Subject: Duke Energy Corporation  
Catawba Nuclear Station, Units 1 and 2  
Docket Numbers 50-413 and 50-414  
Reply to Request for Addition Information  
on Proposed Technical Specifications (TS)  
Amendments to Sections 3.8.4, "DC Sources  
- Operating"; 3.8.5 - "DC Sources -  
Shutdown"; and 3.8.6, "Battery Cell  
Parameters" and Associated TS Bases  
(TAC Numbers MC2618 and MC2619)

### **REQUEST FOR ADDITIONAL INFORMATION** **DUKE ENERGY CORPORATION** **CATAWBA NUCLEAR STATION, UNITS 1 AND 2** **DOCKET NUMBERS 50-413 AND 50-414**

Figure 1: 125VDC Diesel Auxiliary Power Battery 1DGBA Load Profile During a LOCA/ Blackout

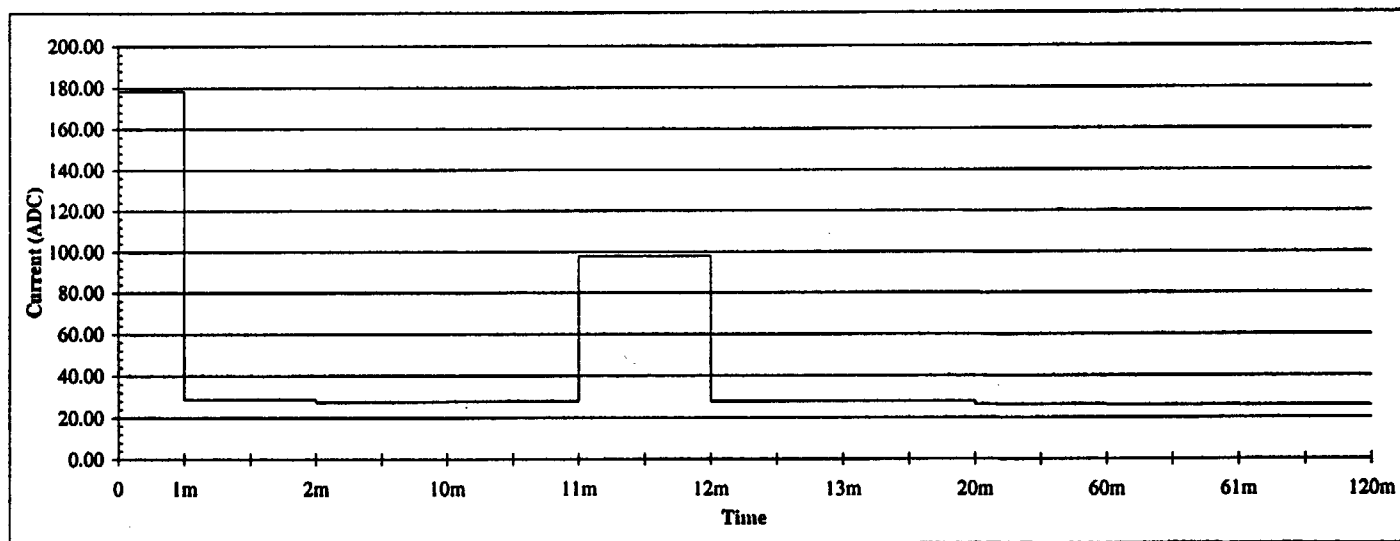
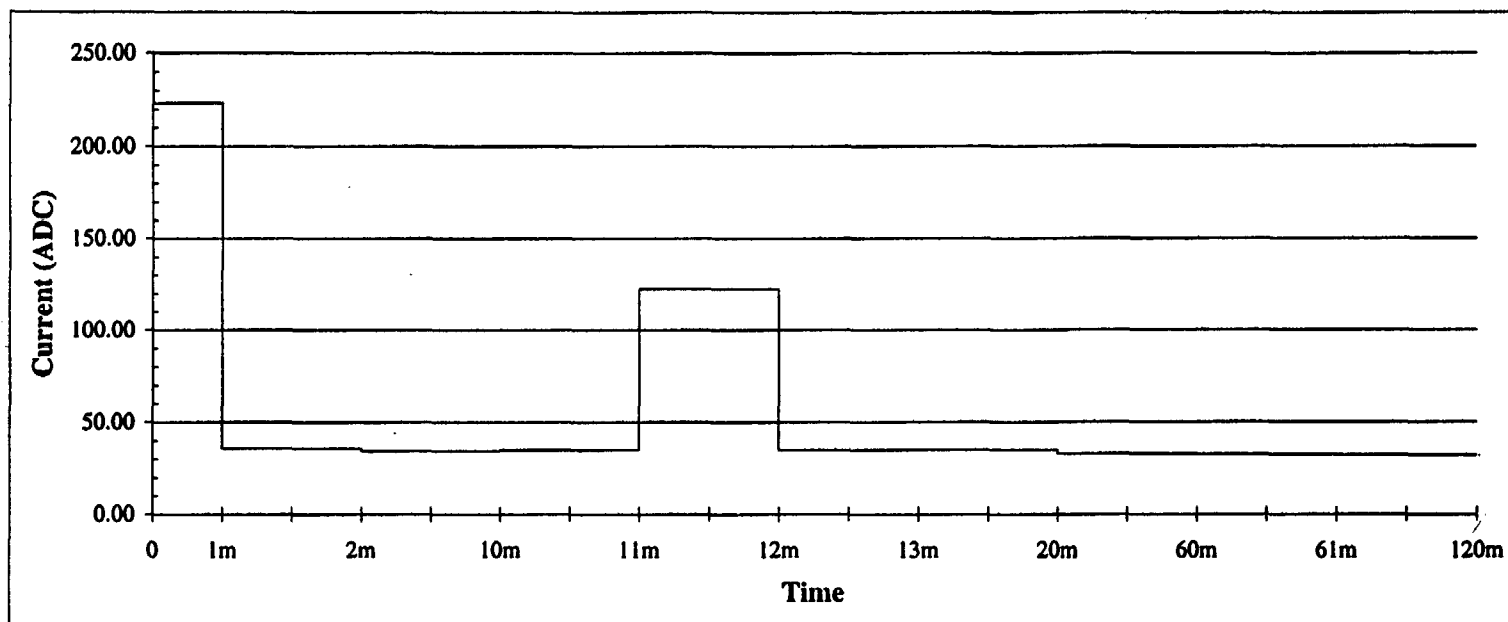
1. Attachment 5 to the "Technical Specifications (TS) Amendment Request" provides Diesel Generator (DG) battery sizing calculations for various load profiles. The worst case is observed to be 1DGBA LOCA-BO with first minute loading as 178.61A. However, per section SR 3.8.4 (marked as SR 3.8.4.7) of TS bases B3.8.4, the DG batteries are tested for 218.5A for the first minute. Also, according to Figure 8-27 of UFSAR, the load for DG batteries is 214.6A for the first minute. Similar differences are observed for the remainder of the load profile between the DG batteries sizing calculation, TS bases, and UFSAR. Please explain why there are differences between the load profiles considered in the calculations for sizing the batteries, TS bases, and the load profile considered for testing of the batteries.

- Worst case DG battery load profile calculation (load profile should agree with load profiles considered in other documents)
- DG battery sizing calculation for the worst case load profile with no cell reversal

The UFSAR Figure 8-27 load value of 214.6A is from the October 1993 revision of the UFSAR. Figure 8-27 has since been revised, and the current October 2001 revision shows a value of 273.1A for the first minute.

The load profile (duty cycle) described in TS bases B3.8.4.8 conservatively envelopes the load profile shown for all four DG batteries, 1DGBA, 1DGGB, 2DGBA and 2DGGB, in the battery sizing calculation. The design basis load profile for each battery is slightly different due to minor load differences between trains A and B and units 1 and 2. For this reason, the battery sizing calculation determines the required capacity for each battery on an individual basis. From an overall size requirement standpoint, DG battery 1DGBA is the worst-case battery. To avoid becoming overly complex, one load profile, which envelopes the load

Please refer to Attachment B for a preliminary copy of the battery load profile and sizing calculations for 1DGBA, assuming no cell reversal. The copy is preliminary due to periodic revisions unrelated to the question above. The portions included in the attachment deal with the worst-case DG battery, which is 1DGBA. These portions of the calculation have been checked and are included on Attachment B. The revision did not change the battery load profile. No significant changes are expected to be made to this portion of the calculation. The calculation revision is expected to be fully checked and approved by the September 9, 2004. A final copy of the calculation for DG Battery 1DGBA can be provided at that time, if desired.
